CHARLES COUNTY GOVERNMENT

ITB NO. 20-35, MATTAWOMAN WWTP FLOW EQUALIZATION BASIN**ADDENDUM NUMBER FOUR**

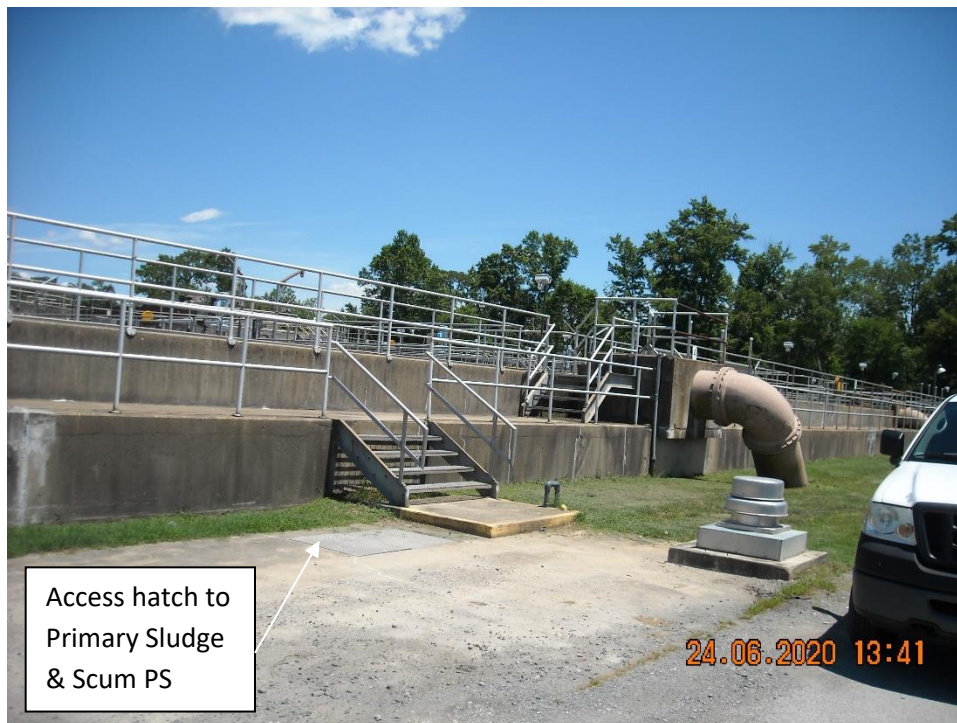
53.	<p>M008: Please provide as built drawings and/or photographs of the interior of the North/South section of the pipe gallery.</p>	<p>See 3. Changes – Appendix 1 – Drawings & Specifications – Drawings – 200508.pdf of this addendum. Refer to M010, Detail 4 and 5 for photographs.</p>
